BASE MODEL: CG3480 ASSET TYPE: FRANCHISE CLASSIFICATION REFRESH OWNER: FOURCROWN, INC 2016 JAN.

FLOOR, FINISH & EQUIPMENT PLAN

9624 LYNDALE AVE S, BLOOMINGTON, MN 55420

EXTERIOR ELEVATIONS

A2.1

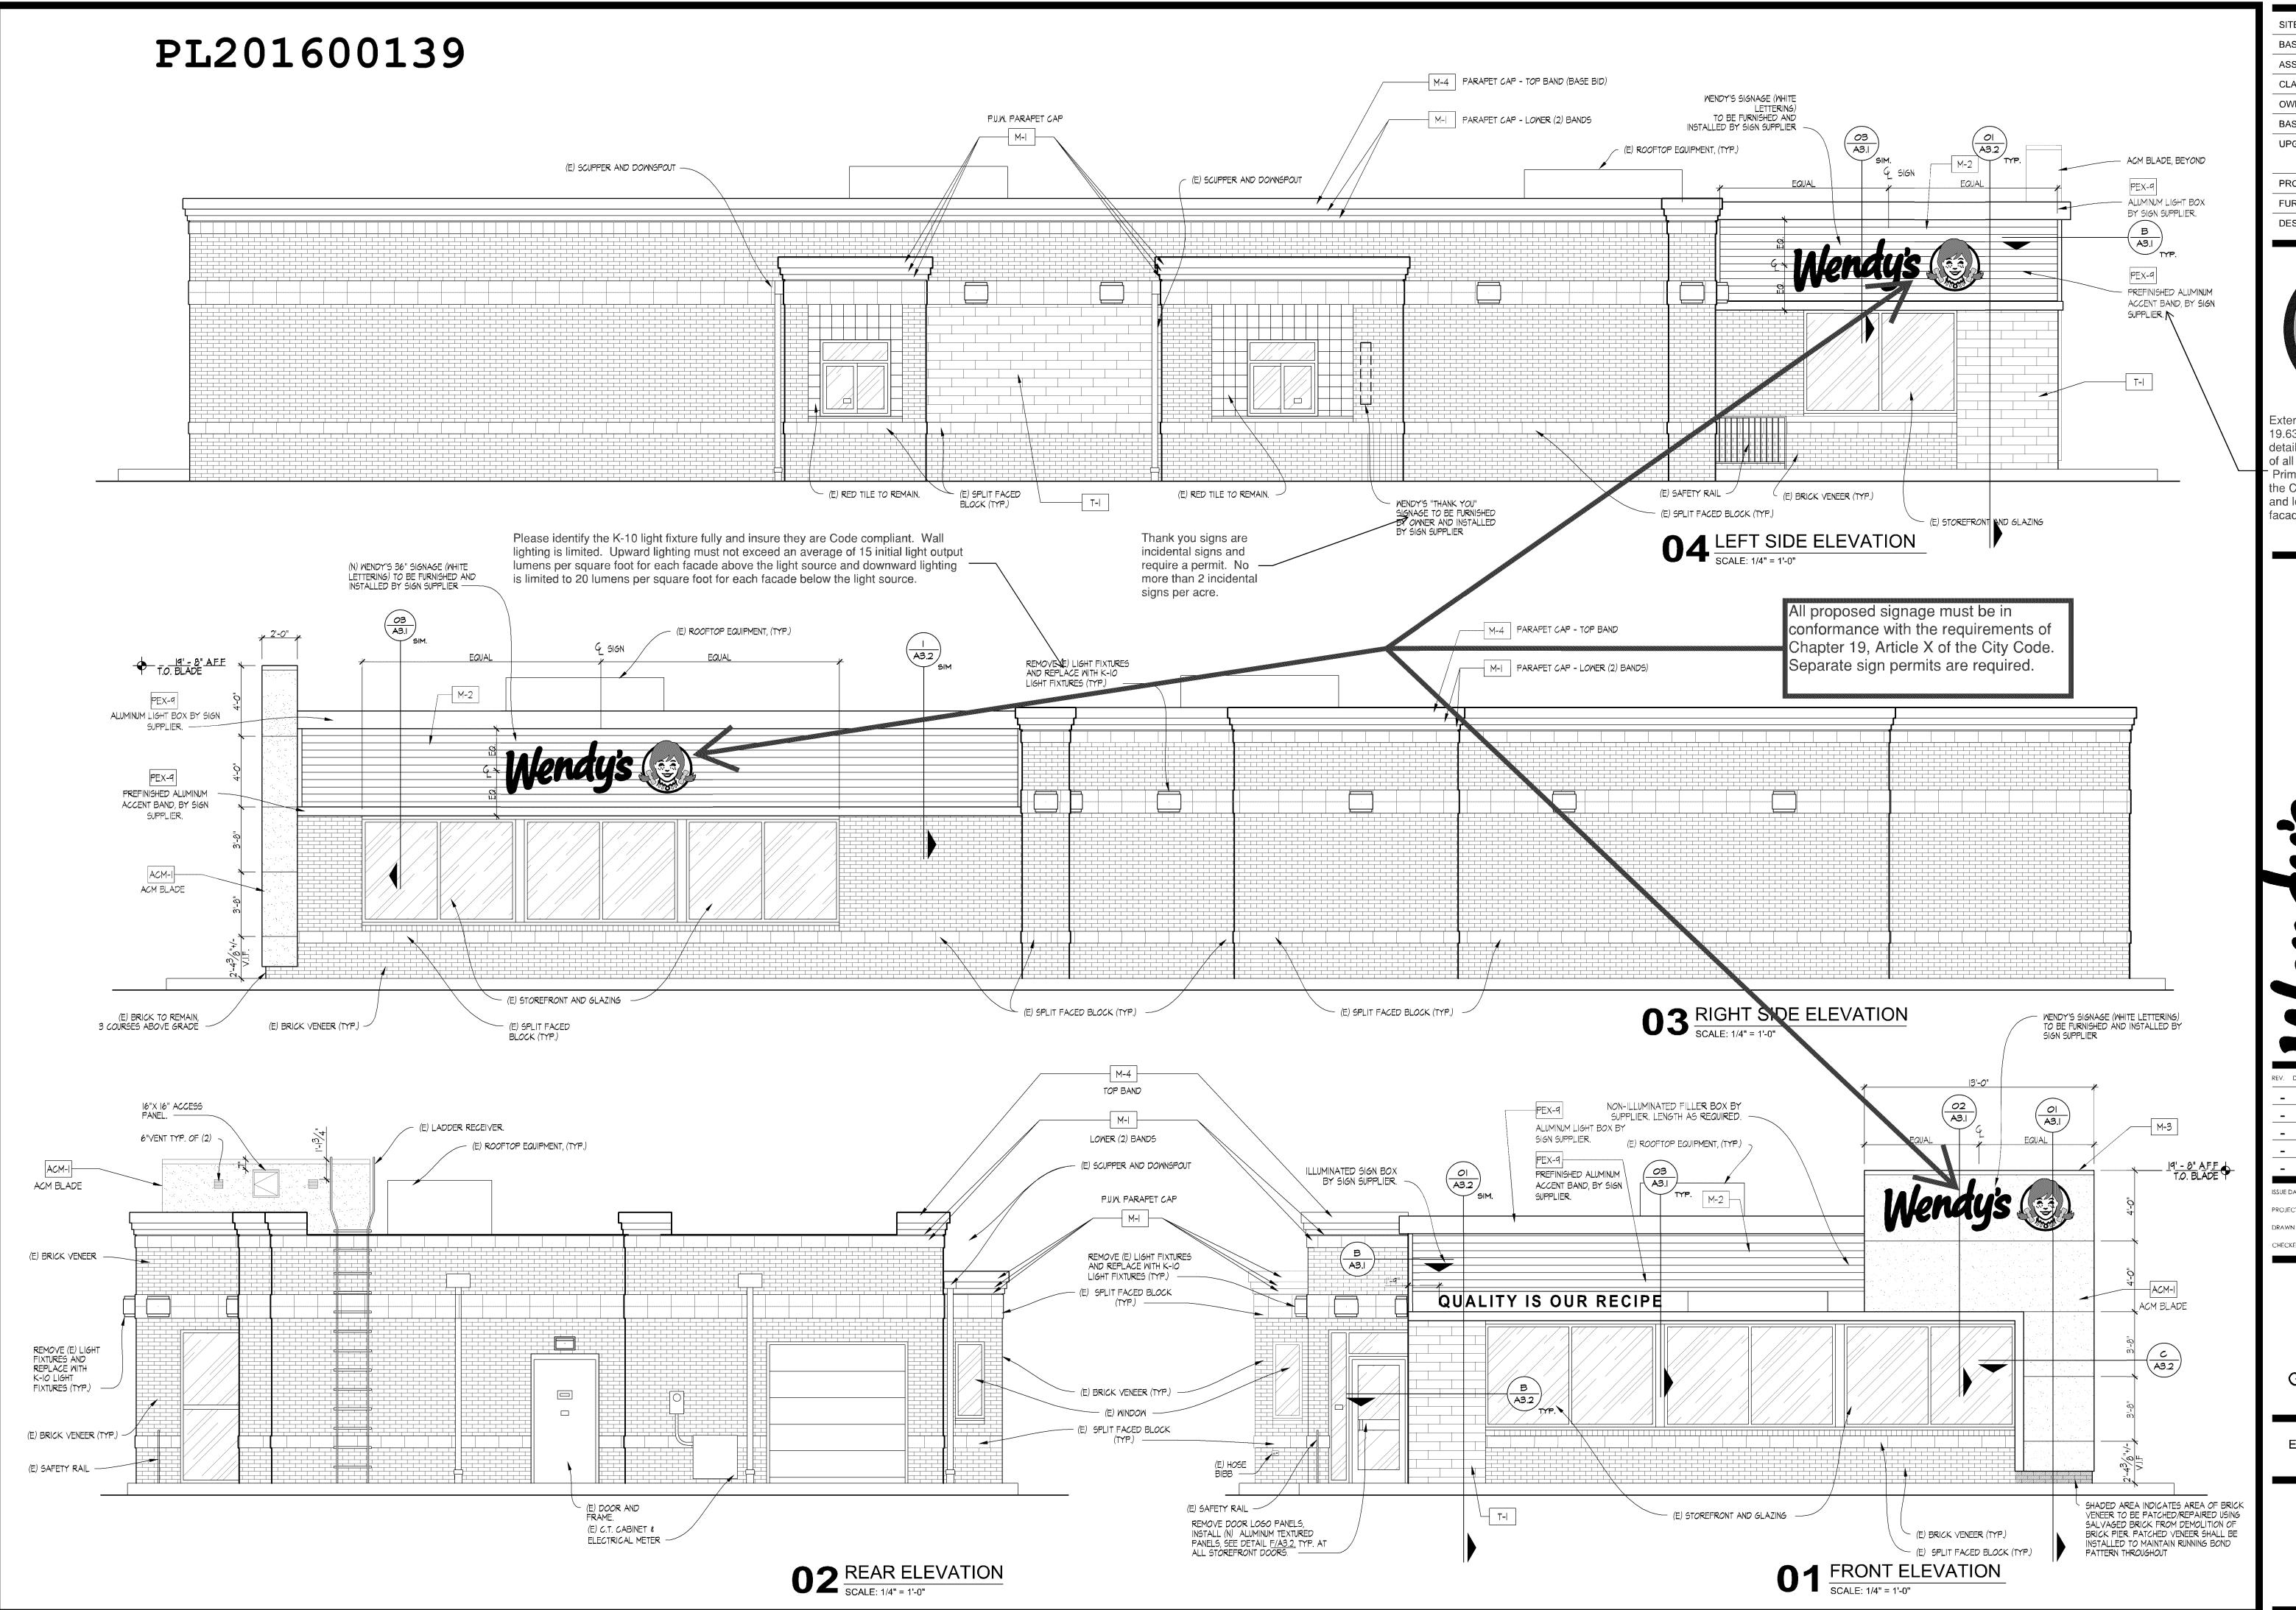
Exterior materials must meet Section 19.63.08 of the City Code. Additional details, including specification sheets, of all new materials must be provided.

Primary metal materials must meet the City's metals policy for durability and longevity. A total of 15% of any facade may be alternative material.
